BURNETT RIVER FLOODPLAIN ACTION PLAN

COMMUNITY REFERENCE GROUP MEETING

MINUTES

**EMAILED INFORMATION
FROM GHD
(FLOW VELOCITIES)**

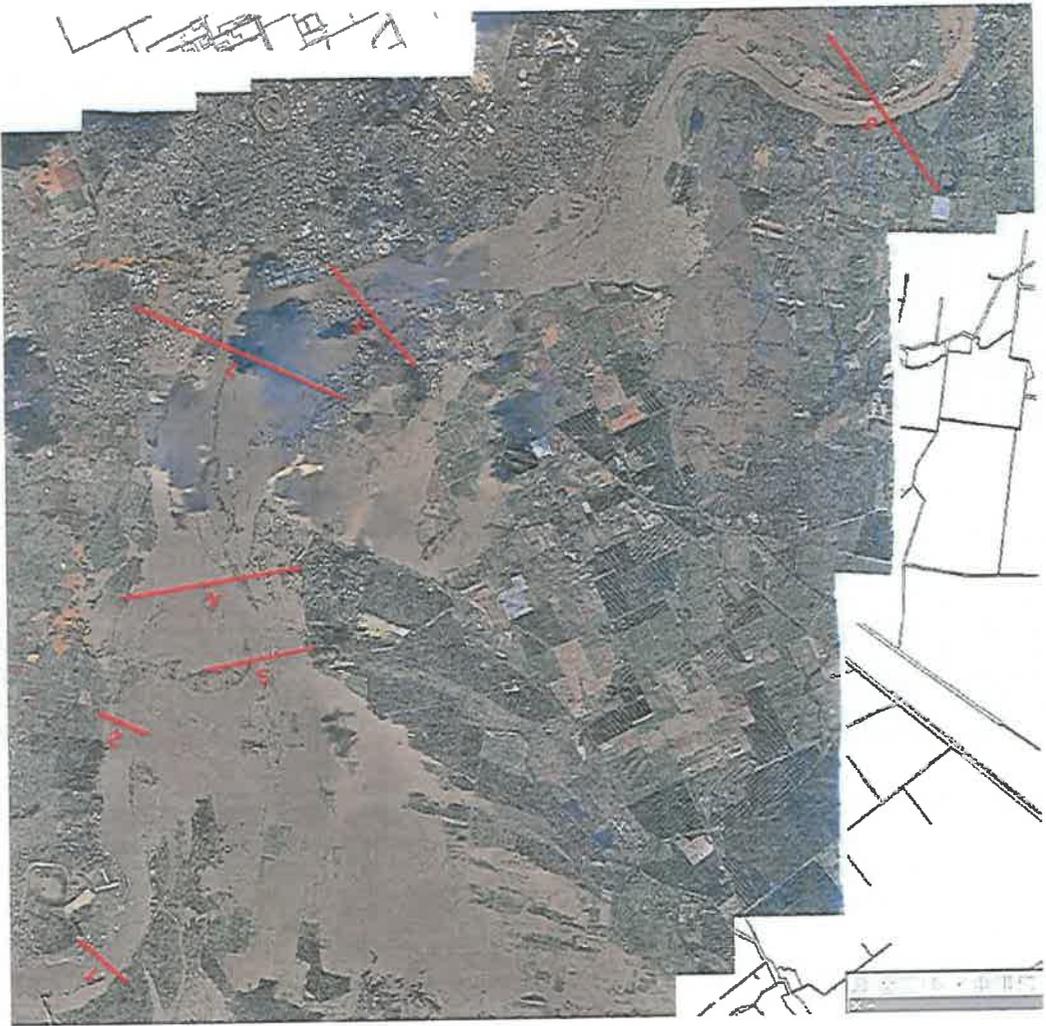
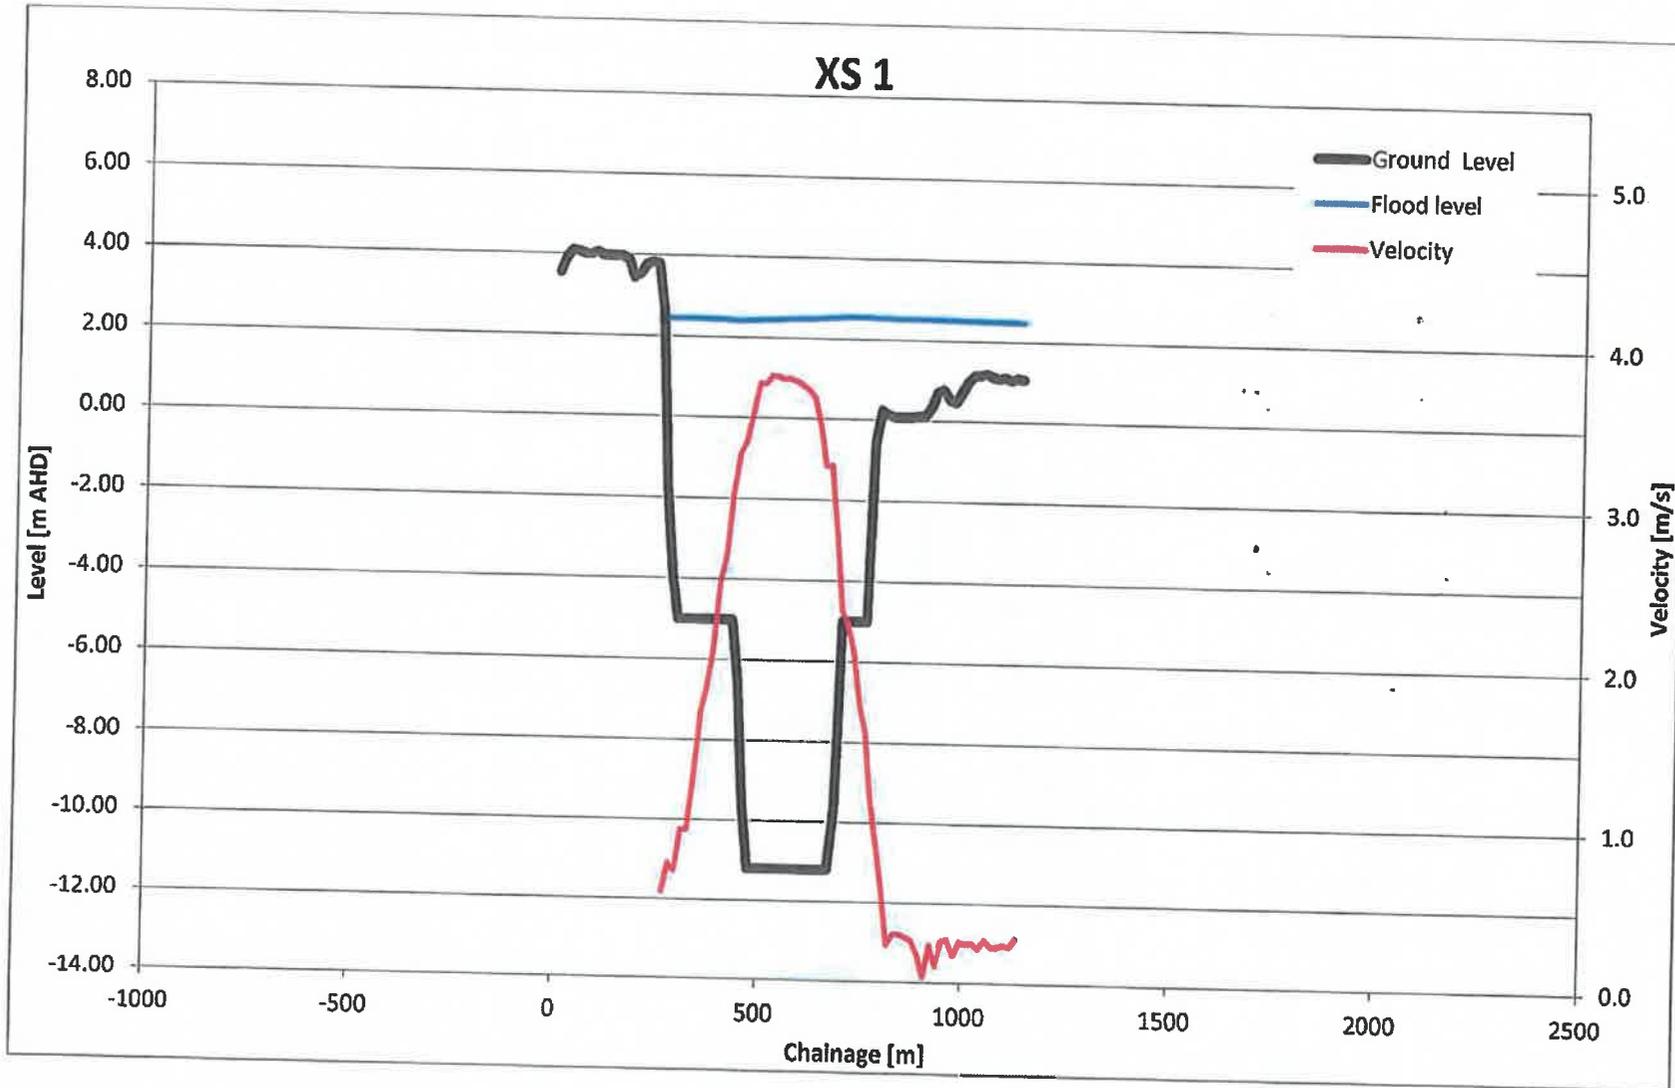
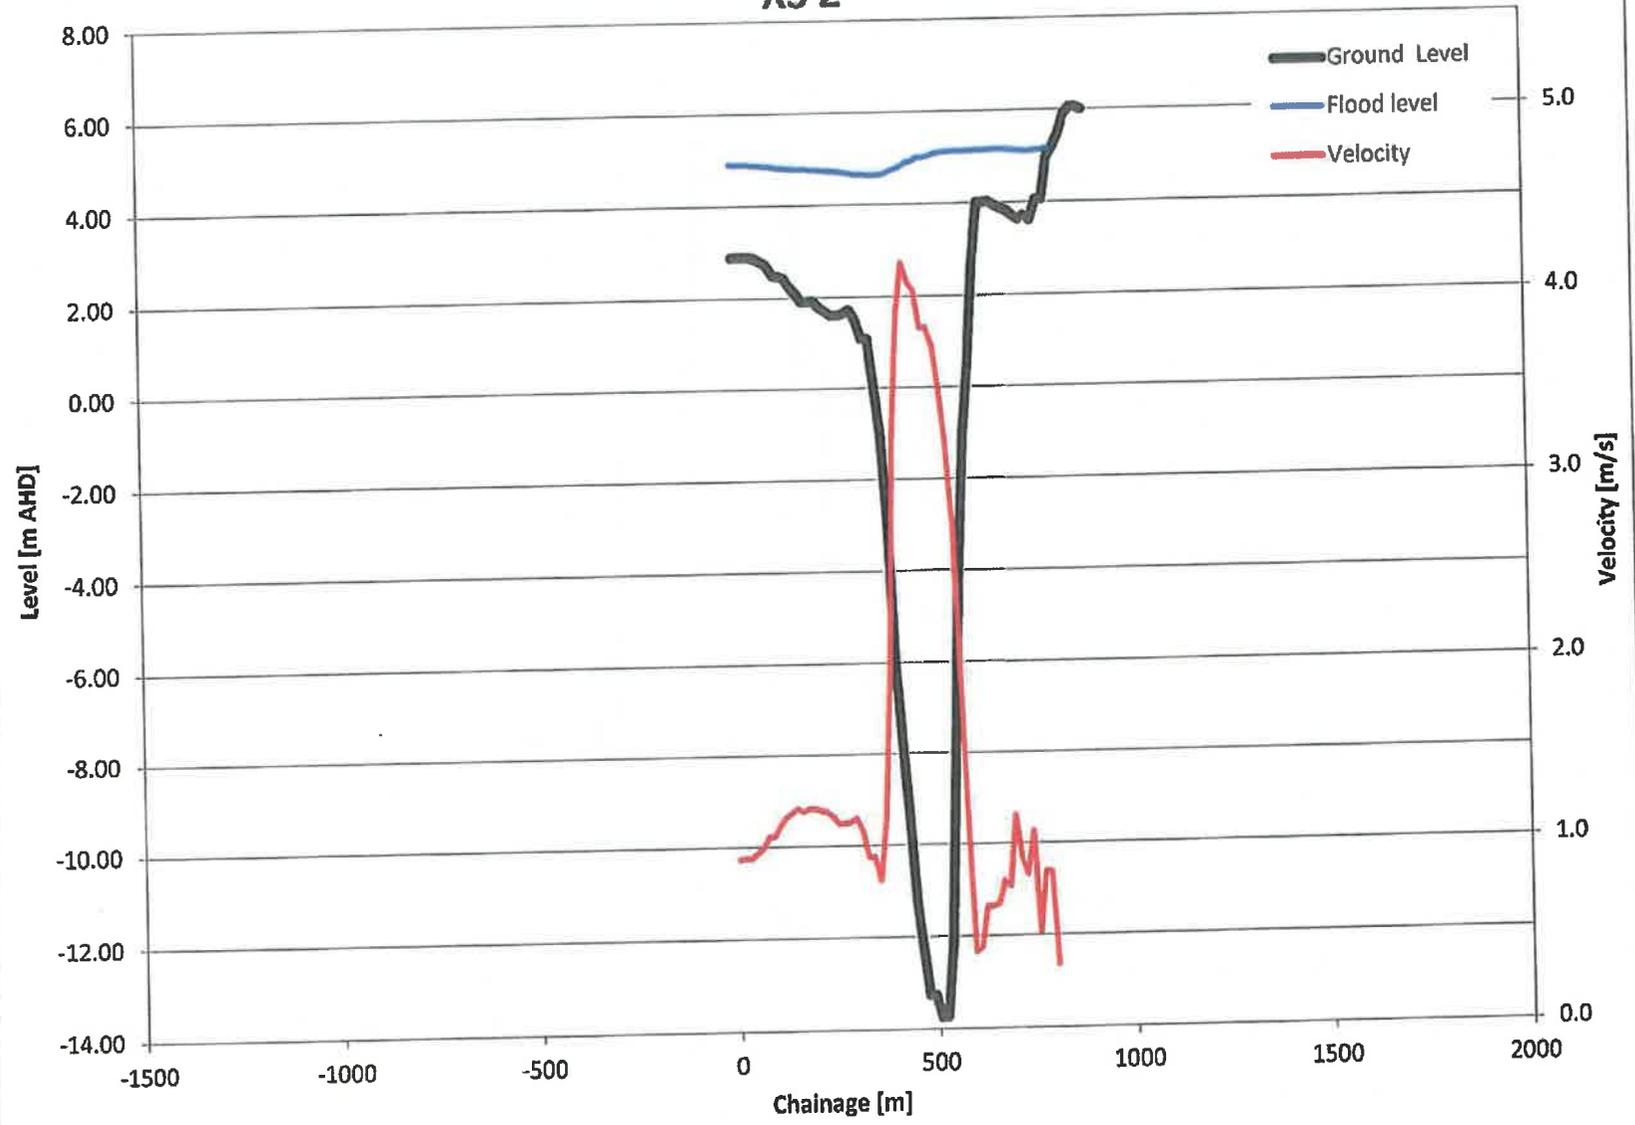
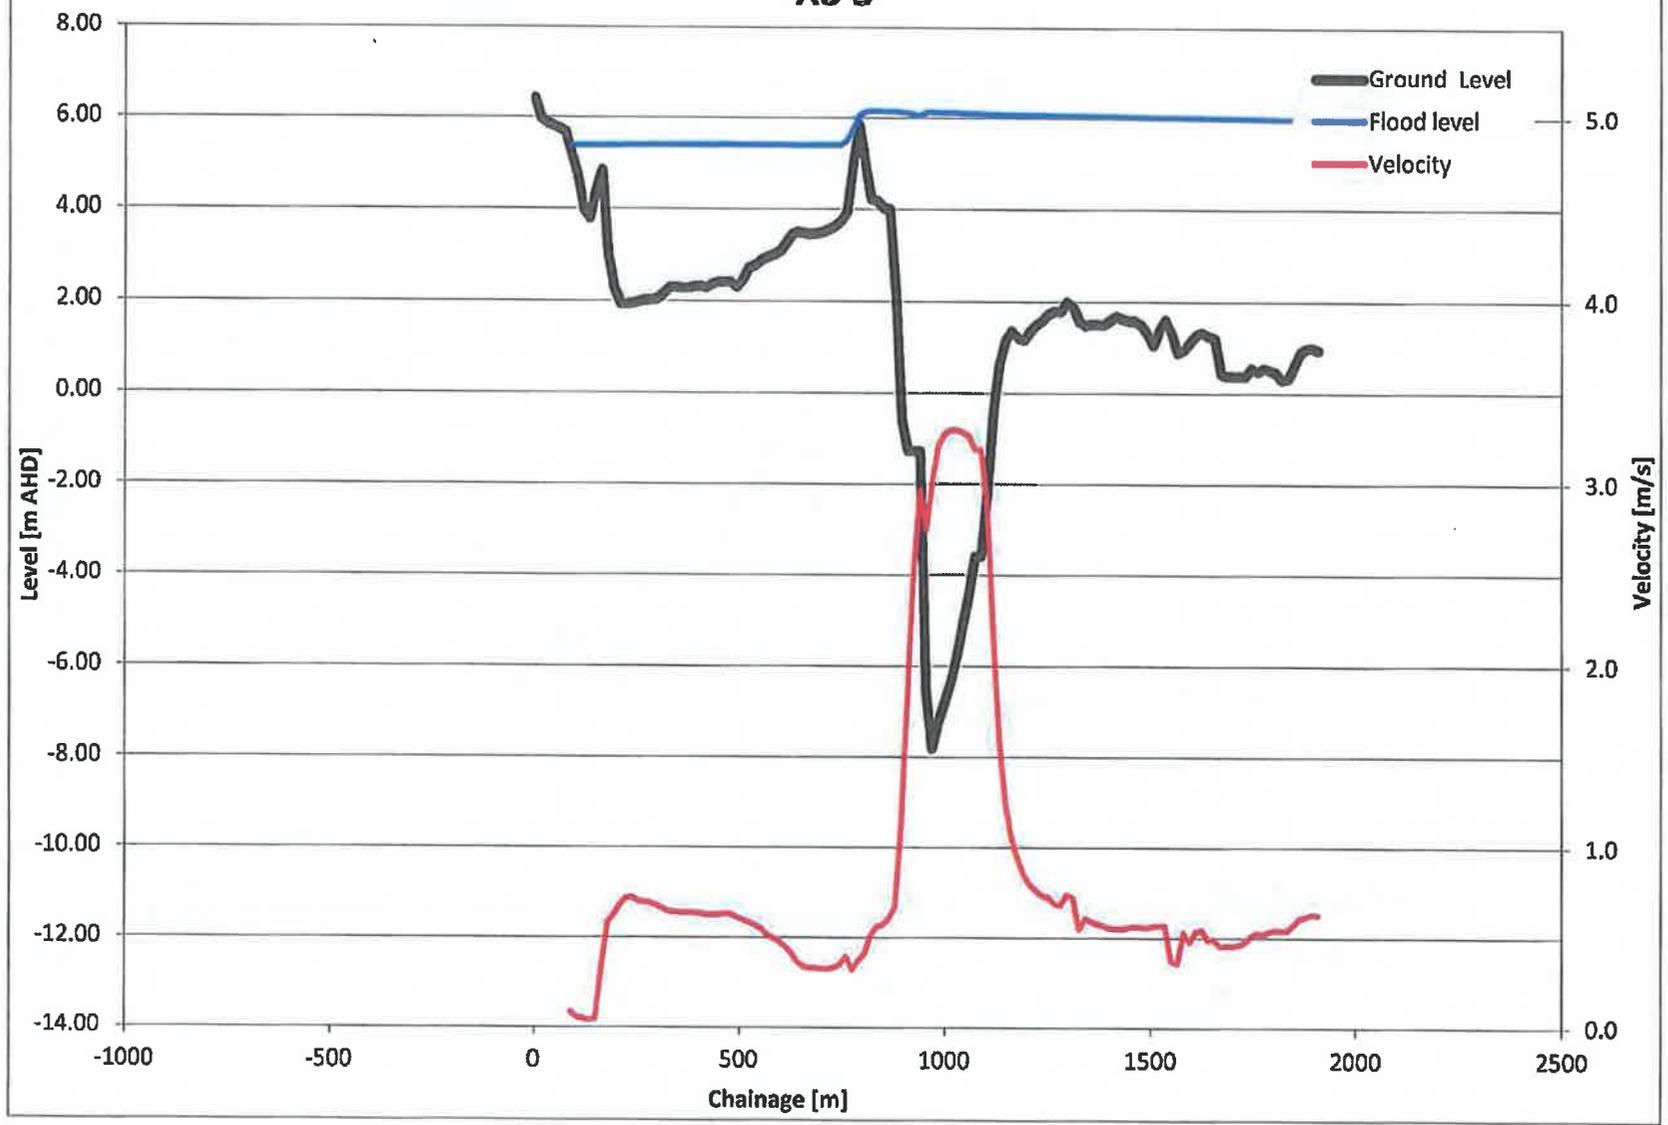
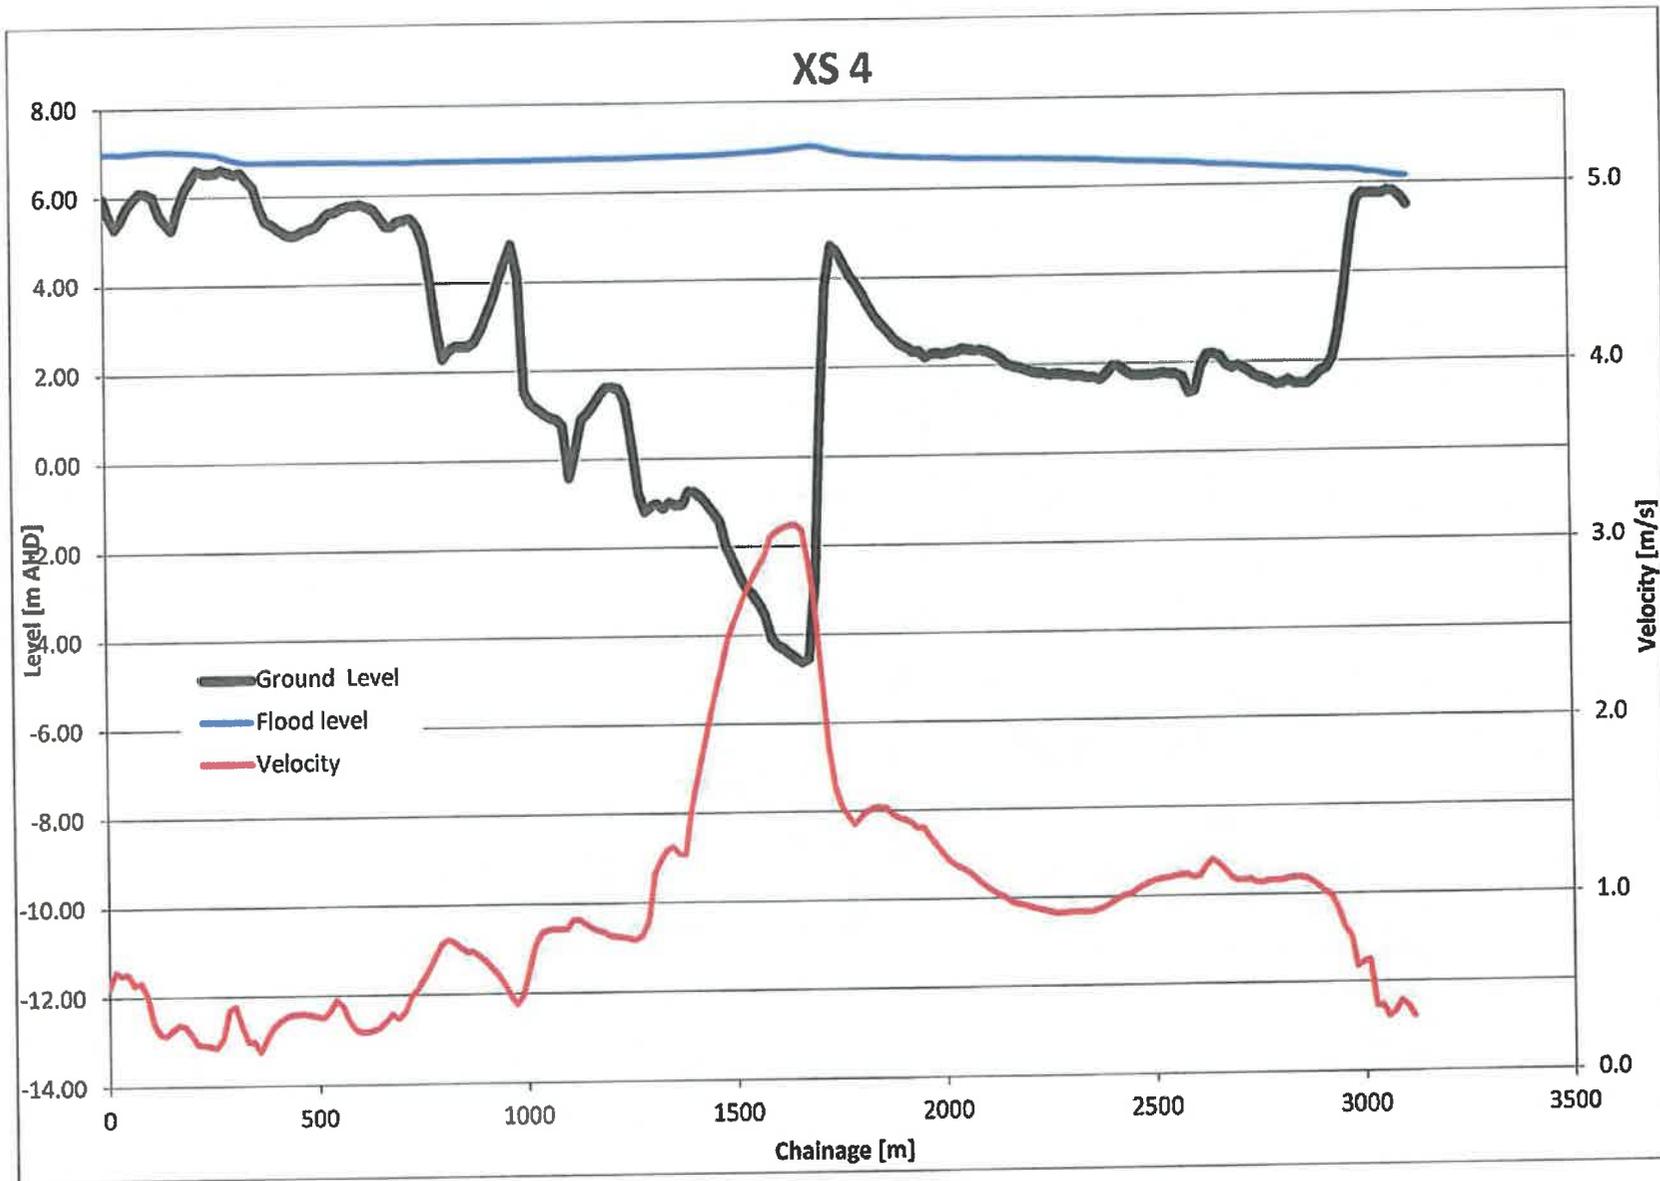
Rob Marshman referred to the flow velocities in GHD's email dated 31 October 2013 (copy attached to these minutes) and stated that many of these recorded velocities seem to be less than what was observed at the time of the 2013 Flood. Dan Copelin explained that the surface velocity is higher than the average velocity taken in a cross section and that whilst some of those surface velocities were excessively high; such velocities will not be shown in GHD's results which only reflect averaged velocities.
